Our Ref: NW30034-L02-2022: BCP/bcp
Contact: Dr Brett C. Phillips

29th June 2022

ADDITIONAL INFORMATION ON FLOODING
200 ALDINGTON INDUSTRIAL ESTATE (SSD-10479), KEMPS CREEK, NSW

Figure 3 Impact of Climate Change on 100 yr ARI Flood Levels (after Figure 8.4, Advisian, 2020)

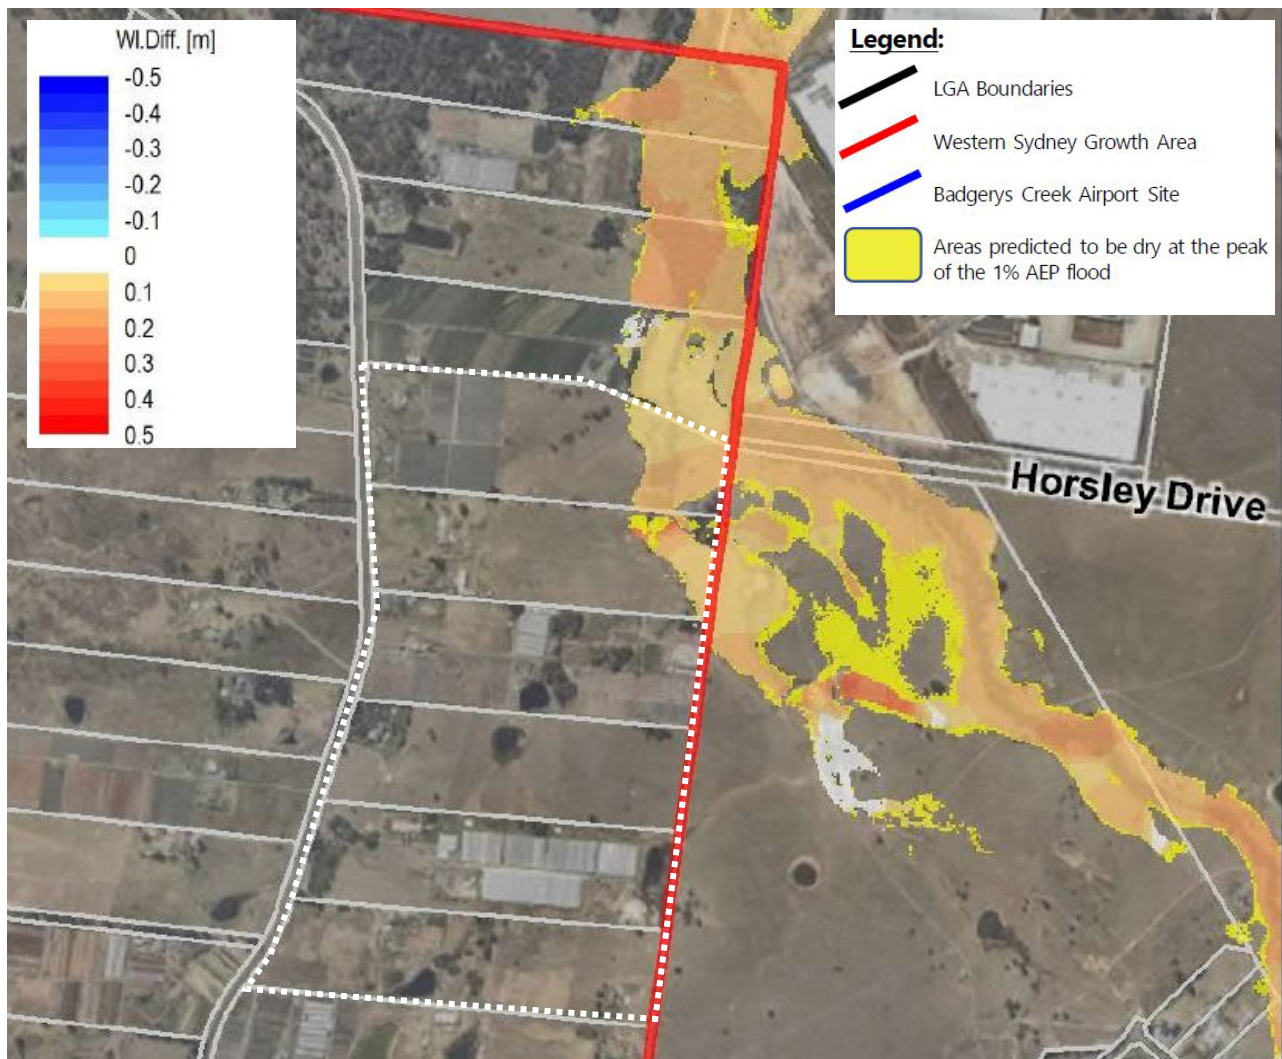
Infrastructure Development & Consulting has raised a concern that: *No evidence of an assessment of climate change has been sighted with the FIA and/or FRA.*

It is estimated from Figure 3 that the impact of climate change impact of climate change on 100 yr ARI flood levels in the vicinity of the subject property is broadly 0.15 m.

- (i) the adopted benchmark 100 yr ARI flood levels are 0.2 m – 0.37 m higher than the 2015 Worley Parsons 100 yr ARI flood levels;
- (ii) the PMF levels are 0.34 m – 0.9 m higher than the 100 yr ARI flood levels;
- (iii) estimated from Figure 3 that the impact of climate change impact of climate change on 100 yr ARI flood levels in the vicinity of the subject property is broadly 0.15 m; and
- (iv) the fill platforms typically have 4+ m freeboard to the PMF level;

then it is concluded that any impact of climate change or floodplain revegetation on mainstream flood levels will not have any impact on the development.

EARTHWORKS IN
FLOODPLAIN

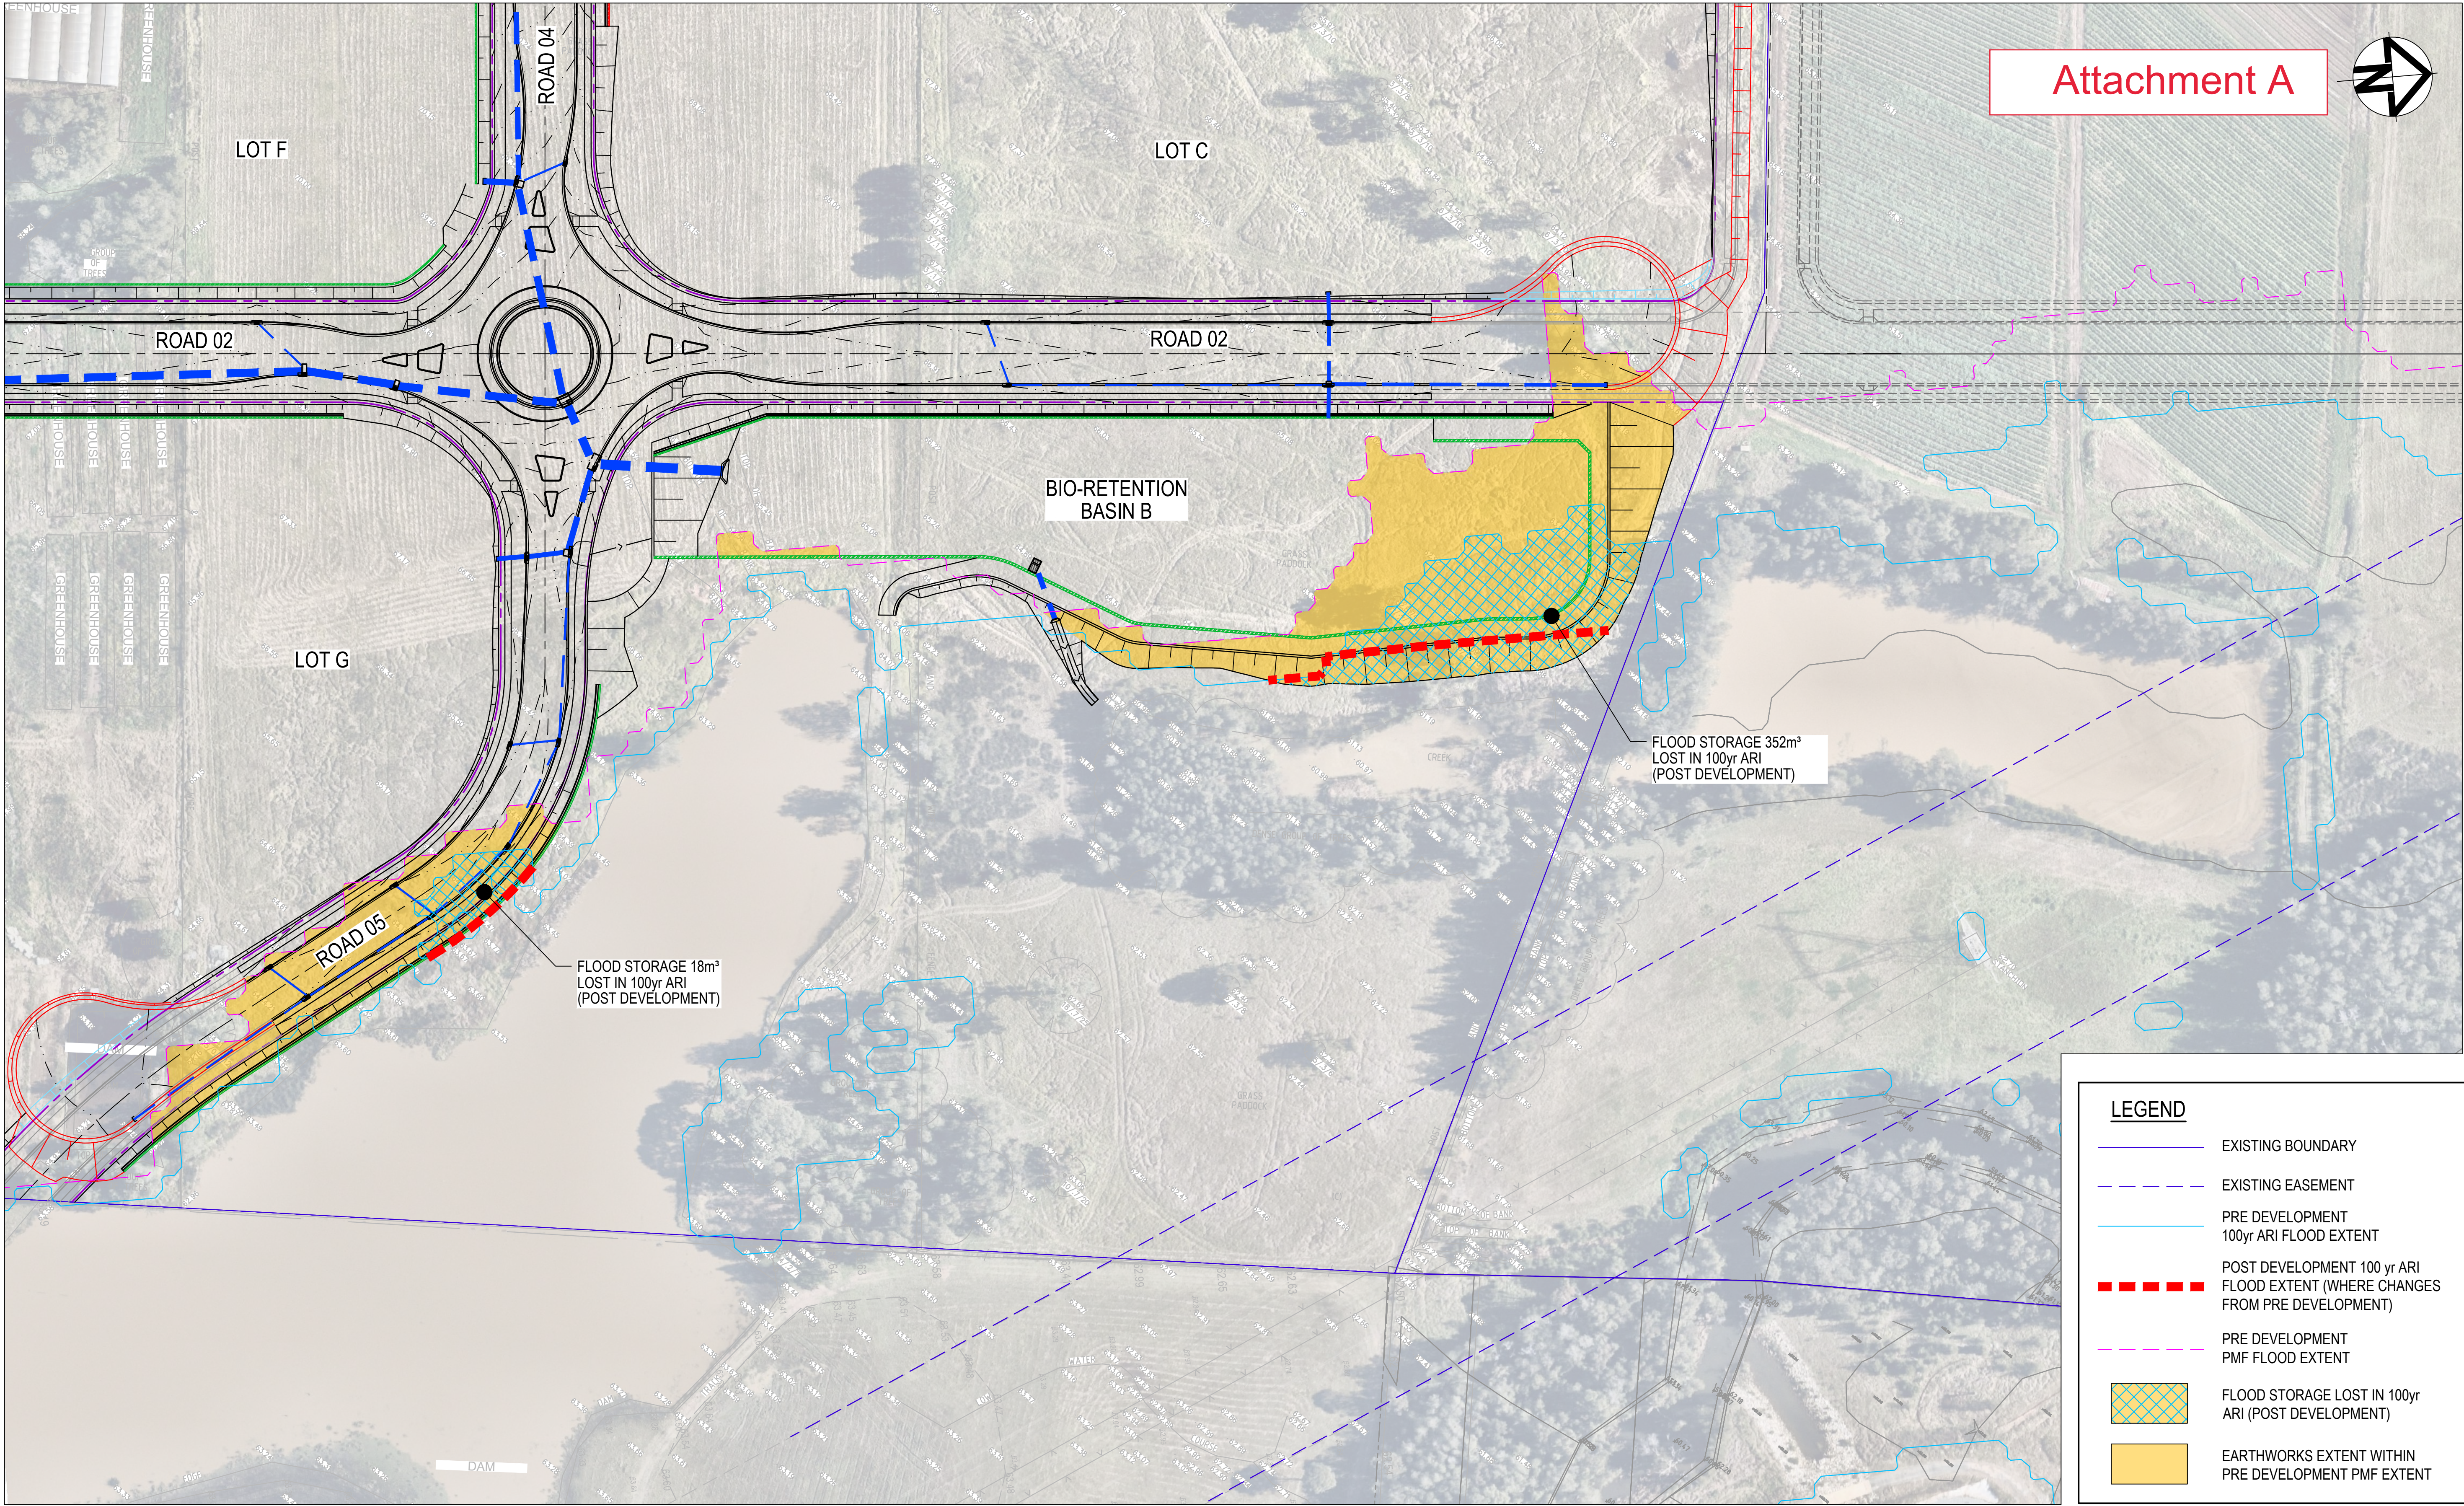
The planned development of 200 Aldington Road, Kemps Creek is also estimated to reduce the 1% AEP flood storage by 343 m³ due to the proposed Road 5 embankment earthworks just encroaching into the 1% AEP flood extent as well the proposed Basin B encroaching to a limited degree into the 1% AEP flood extent.

The planned development of 200 Aldington Road, Kemps Creek is also estimated to reduce the 1% AEP flood storage by 343 m³ due to the proposed Road 5 embankment earthworks just encroaching into the 1% AEP flood extent as well the proposed Basin B encroaching to a limited degree into the 1% AEP flood extent.

The proposed earthworks in the floodplain are presented in Drawing 19-609-SKC124 Issue P1 which is attached. The extent of incursion of proposed earthworks into the 1% AEP flood extent is also delineated.

The reduction in the 1% AEP flood volume was also compared to the 1% AEP 9 hour flood volume and was found to represent a 0.021% reduction in the flood volume.

It was concluded that the impact of the proposed earthworks on 200 Aldington Road on 1% AEP flood storage is negligible and will have nil impact on any adjoining development.
